SUBJECT: Forwards addl info re control of min wall thickness in ASME Class 1, 2 & 3 piping sys at plant. Encl tables provide results of in situ exams of piping in RHR & component cooling water sys. Info resolves concerns re SER Open Item 4.

SHEARON HARRIS NUCLEAR POWER PLANT  
UNIT NO. 1 - DOCKET NO. 50-400  
CONTROL OF MINIMUM WALL THICKNESS

SUBJECT MIN - WALL SER OI 4

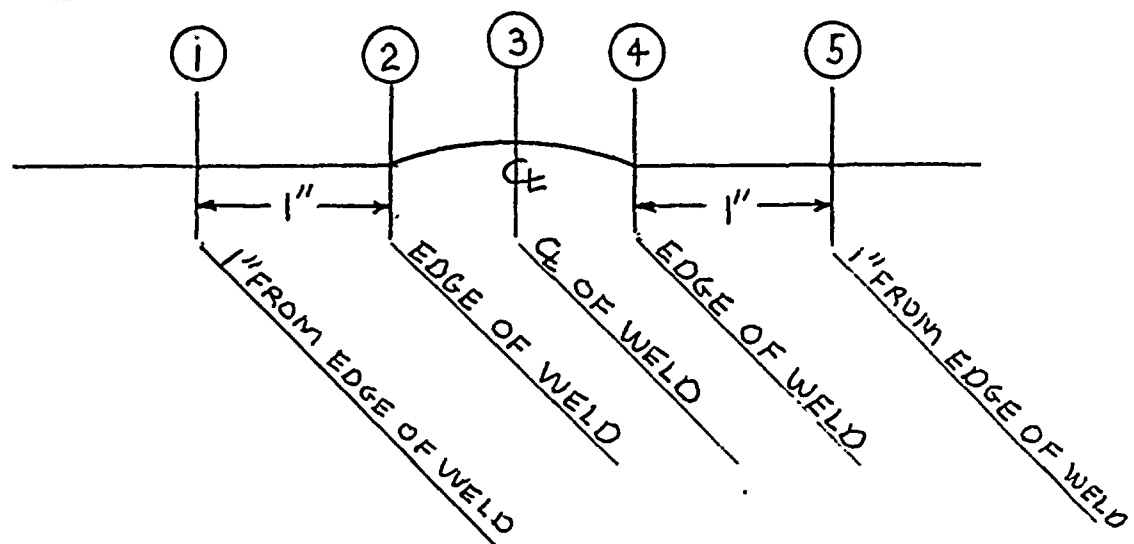
RESPONSE TO NRC STAFF QUESTION RAISED IN AUG. 17, 1984 MEETING

| WELD NO. | LINE NUMBER   | ①         | ②         | ③         | ④         | ⑤         | SCH. | *MIN. WALL |
| 1        | 3CC18-6SB-1   | .432-.482 | .436-.466 | .504-.563 | .387-.448 | .387-.448 | STD. | .328       |
| 2        | 3CC12-15SB-1  | .362-.424 | .336-.424 | .448-.508 | .378-.407 | .378-.398 | STD. | .328       |
| 3        | 3CC12-12SA-1  | .362-.400 | .360-.402 | NONE      | .382-.420 | .387-.418 | STD. | .328       |
| 4        | 3CC18-3SA-1   | .450-.512 | .472-.508 | .542-.583 | .387-.432 | .380-.432 | STD. | .328       |
| 5        | 3CC20-11SN-1  | .359-.402 | .356-.406 | .360-.509 | .366-.403 | .366-.396 | STD. | .328       |
| 6        | 3CC20-11SN-1  | .335-.418 | .332-.403 | NONE      | .389-.404 | .365-.394 | STD. | .328       |
| 7        | 3CC14-413SN-1 | .381-.406 | .386-.427 | .410-.462 | .374-.392 | .372-.394 | STD. | .328       |
| 8        | 3CC6-255SN-1  | .262-.290 | .268-.304 | NONE      | .282-.320 | .285-.332 | 40   | .245       |
| 9        | 3CC6-256SN-1  | .282-.316 | .278-.314 | NONE      | .264-.313 | .259-.317 | 40   | .245       |
| 10       | 3CC12-15SB-1  | .365-.445 | .348-.368 | NONE      | .332-.382 | .342-.424 | STD. | .328       |

\*  $T_m = T_n \times .875$
